JACK LONDON
PARK
PARTNERS

Re: Notice of Preparation for the Eldridge Renewal Project at the Sonoma Developmental Center

Exhibit 2: High-level summary of potential Project impacts and appropriate alternatives

Figure 14. Showing proposed water and sanitary sewer system, in relation to riparian setbacks.

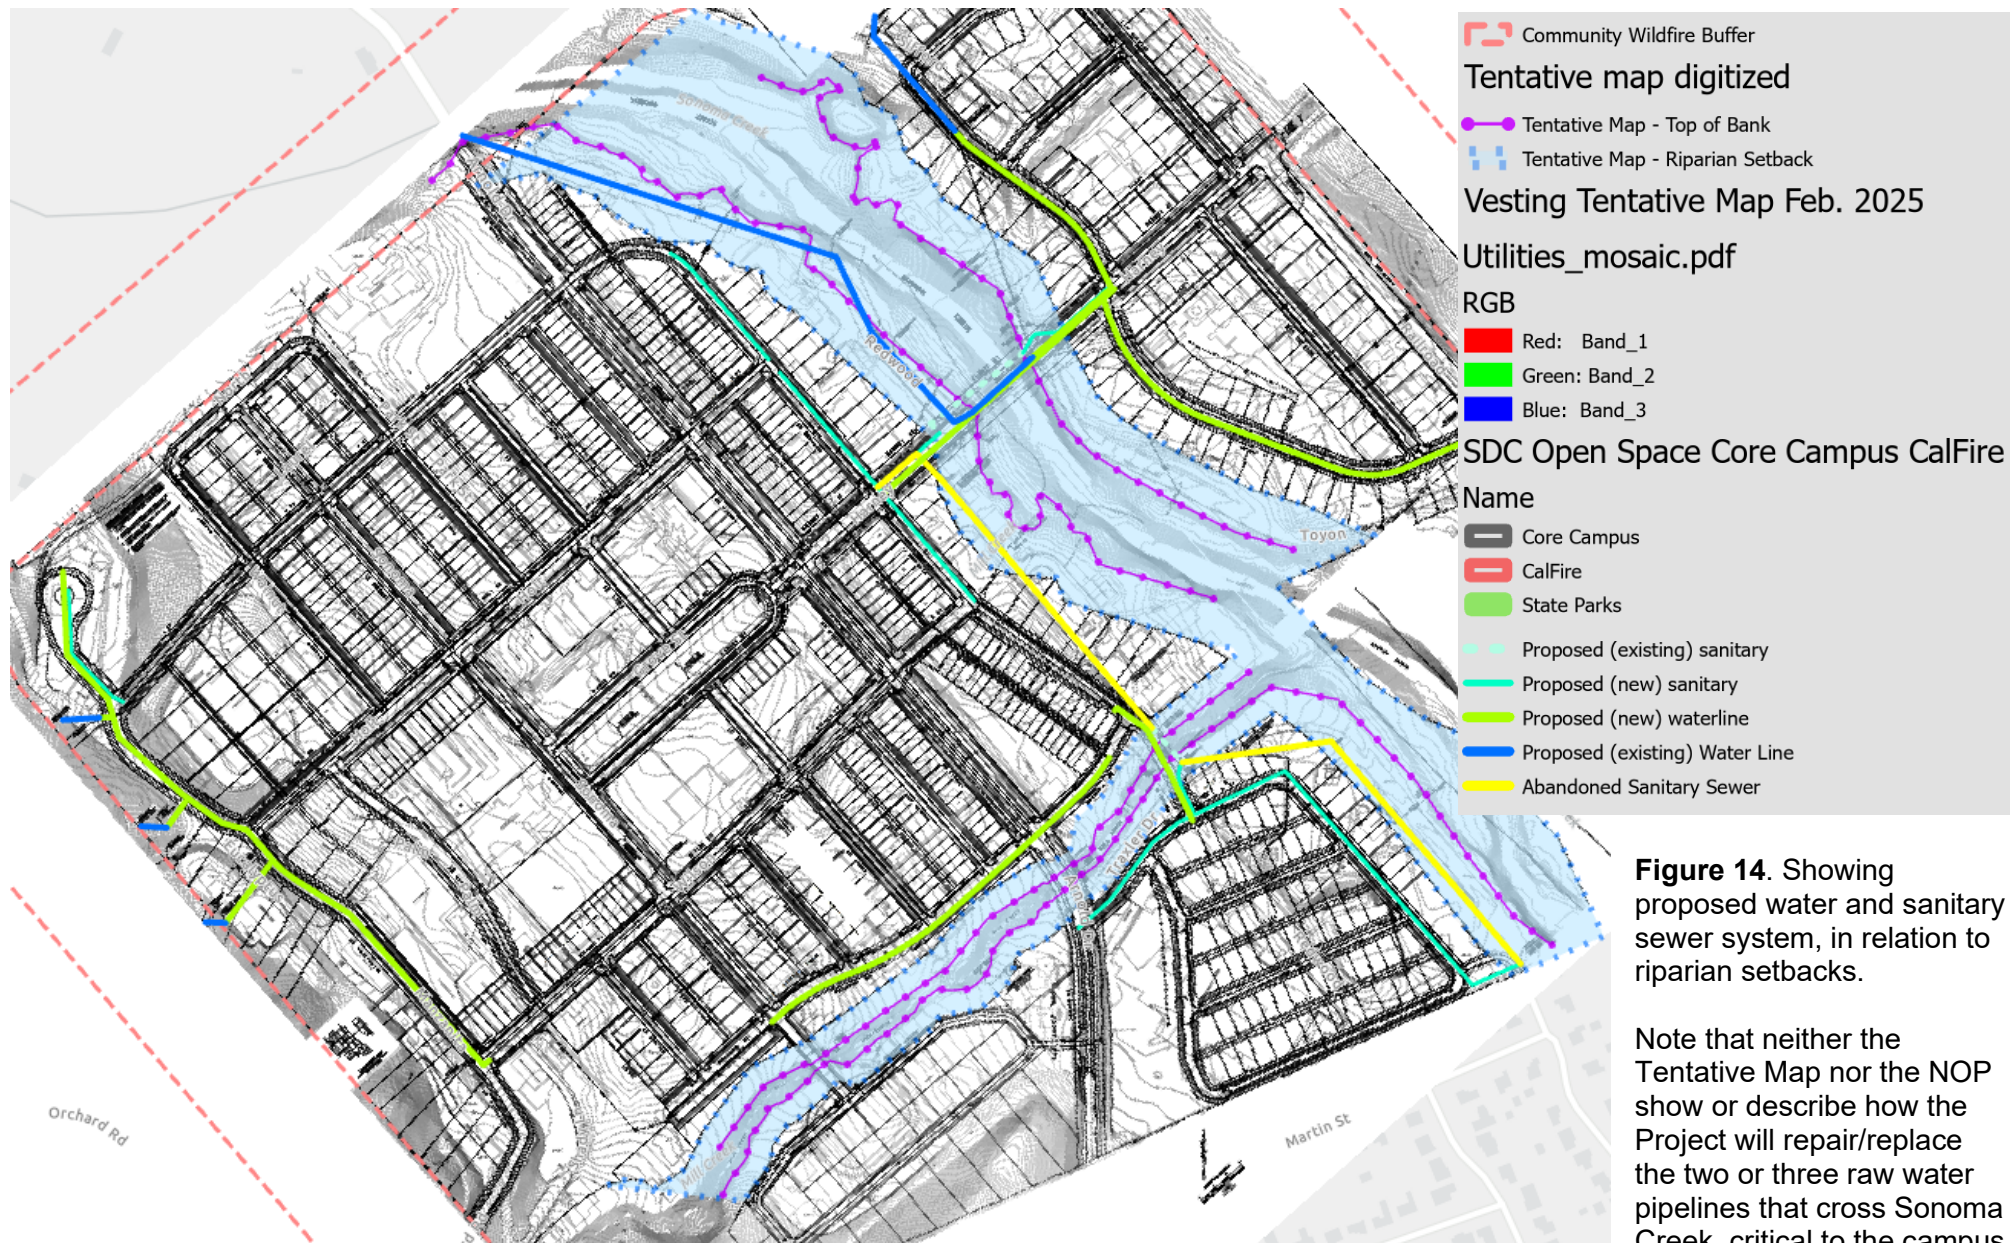
Note that neither the Tentative Map nor the NOP show or describe how the Project will repair/replace the two or three raw water pipelines that cross Sonoma Creek, critical to the campus water supply.

Figure 14. We utilized Project documents to digitize locations of proposed structures around edge of campus and along creeks, then buffered proposed structures by 100', and calculated the overlap between the 100' defensible space zone, the fire buffer, riparian areas, and neighboring properties.

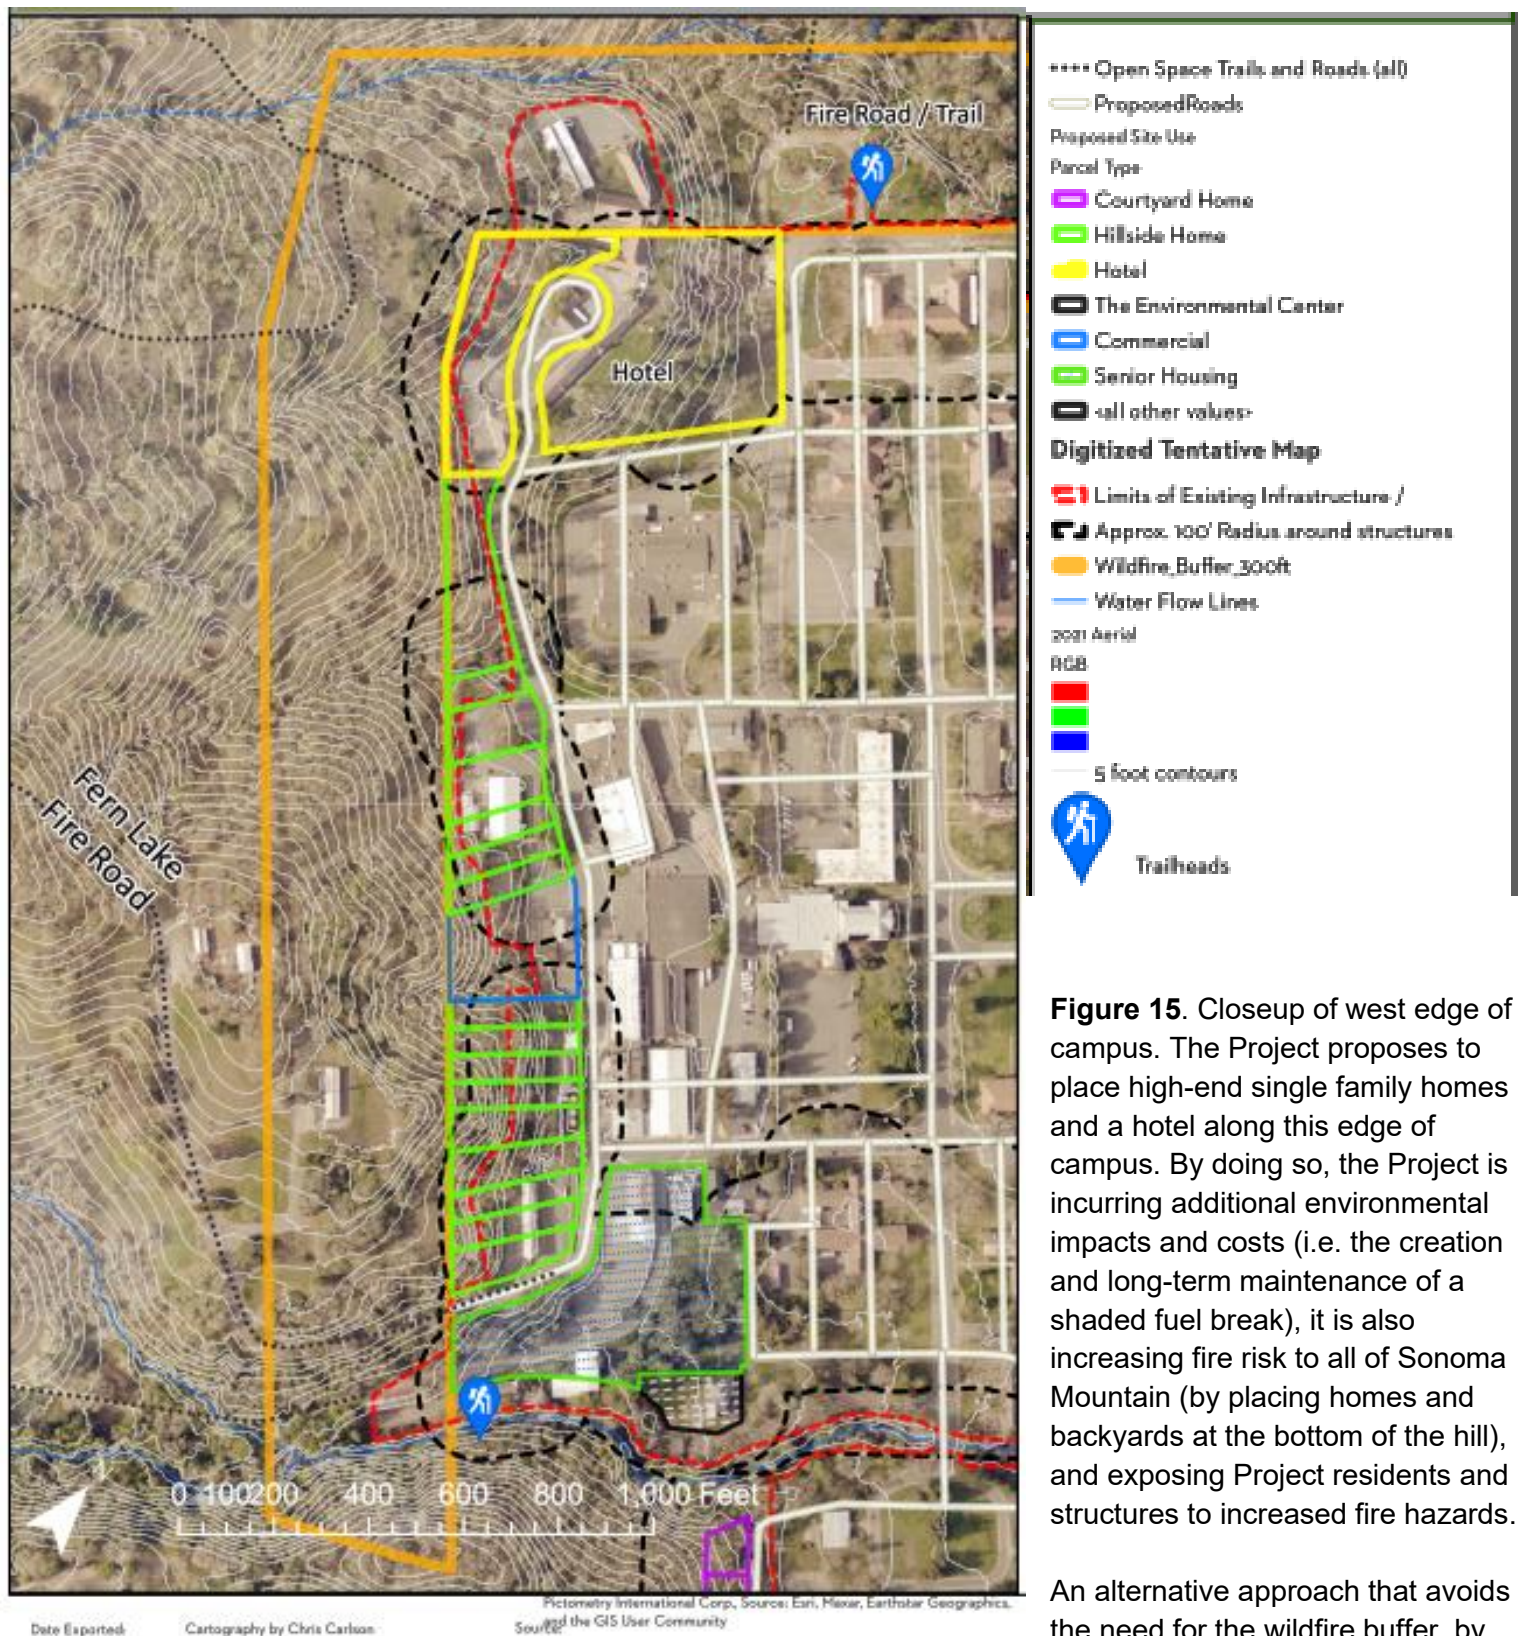
We found very little overlap (2 acres) between 100' defensible space and the wildfire buffer, leading to the conclusion that the fire buffer will not significantly reduce fire risk for the Project. Scientific literature analyzing factors influencing structure survival provide little evidence that fuel reduction beyond 100' improves structure survival. We also found that the 100' defensible space zone around buildings extends well into proposed riparian setbacks, and on to neighboring properties to the south. The Project must choose between 1) Increased fire risk to structures near riparian zones OR 2) impacts to riparian areas from fuel reduction, in the current Project configuration. Using a "creek facing" design, where homes are across a street or path further from riparian areas, would largely avoid this issue.

Figure 18. Map showing water diversions, locations of existing erosion, and potential water/stormwater related impacts.

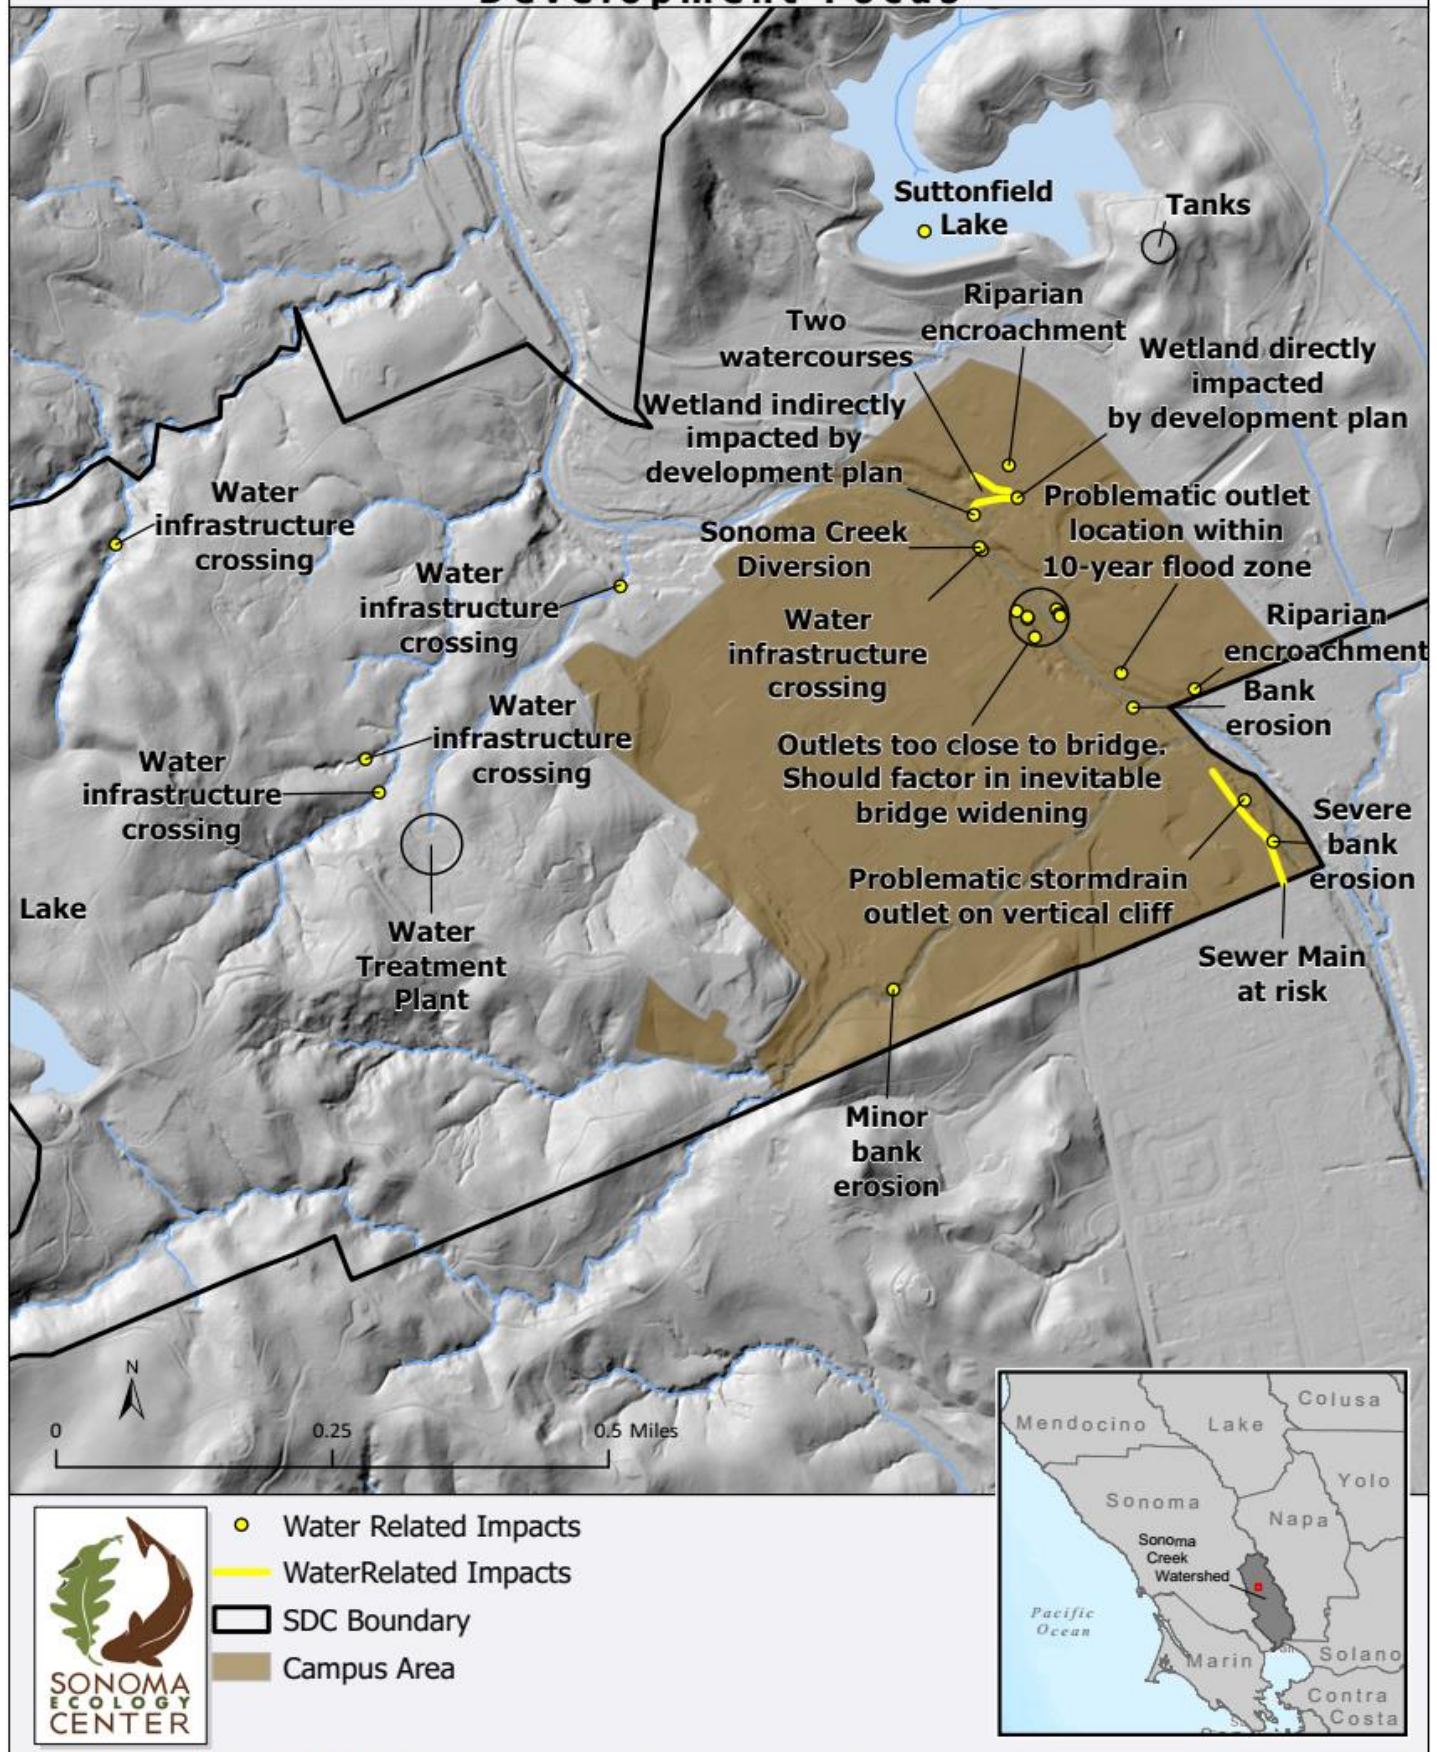
The Project proposes to re-develop a public water supply using surface water rights located largely on State Parks, using water from 2 reservoirs, 4 creeks, and 1 perennial spring complex. This water system is largely on lands outside of the Project Area described in the NOP. Existing infrastructure is in partial or total disrepair, requiring not only repair, but also re-construction of points of diversion, raw water pipelines, water treatment plant, treated water pipelines, pump stations, intakes in reservoirs, above ground ditches, and creek crossings, and associated electrical service and defensible space around infrastructure (Sherwood Hydrology and Site Infrastructure Report 2018, SDC Water System Assessment Report 2023). See Figures 3, 17-18, Exhibit 3.

Figure 20. This map shows Mountain Lion GPS Collar data from the Living with Lions project obtained between 2016-2023, in comparison with the Core Campus, Riparian setback, Wildlife Buffer, and 'Critical Linkage' from a 2013 report. *Data Credit:* Audubon Canyon Ranch, and True Wild.

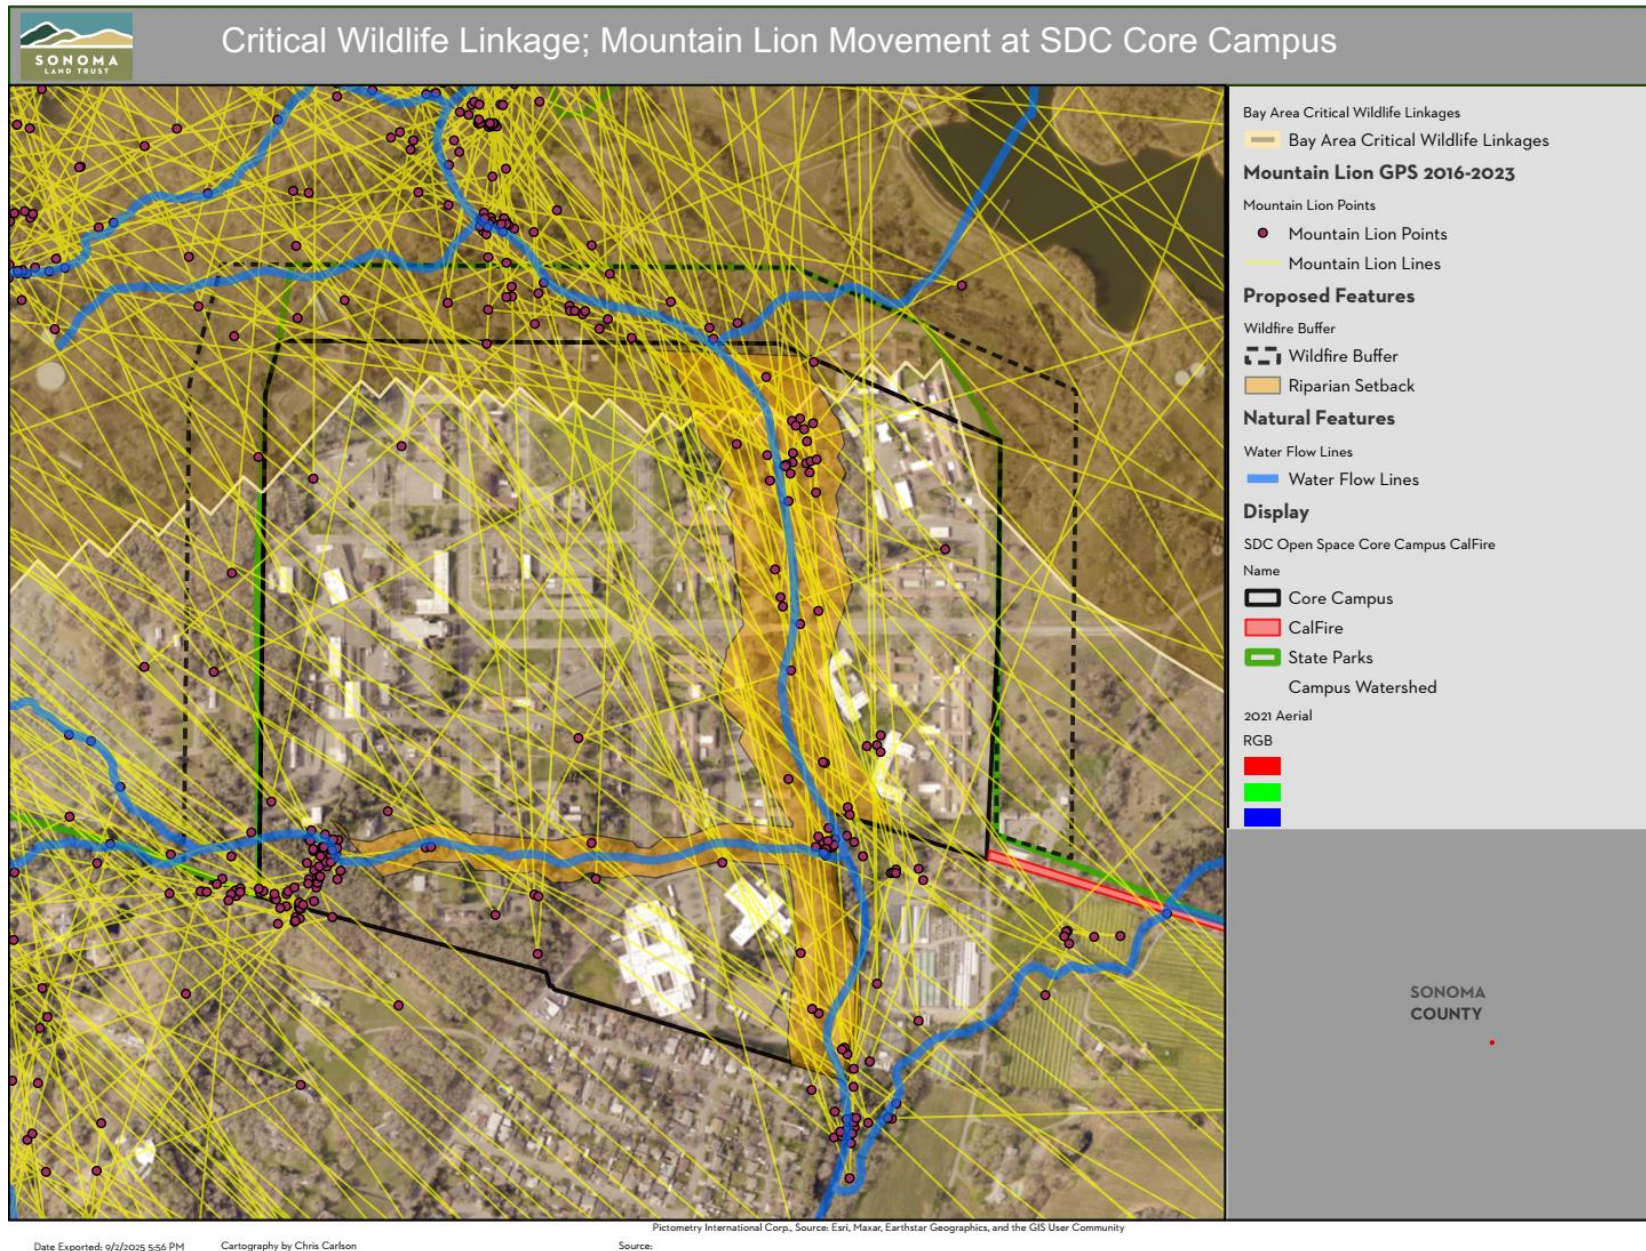
- Conclusions:
1. Although we can't say for sure where lions move between GPS points, it is clear that lion movement across the SDC occurs in the current condition and will likely change if the Project is constructed.
 2. Lions prefer Sonoma Creek for movement. To protect Sonoma Creek as a movement corridor, sufficient buffers and protections need to be put in place.
 3. The Project proposes buildings within the 2013 critical linkage.

To avoid impacts to mountain lion movement, the Project must consider alternative design measures for the design and layout of riparian setbacks as described in the alternatives above.
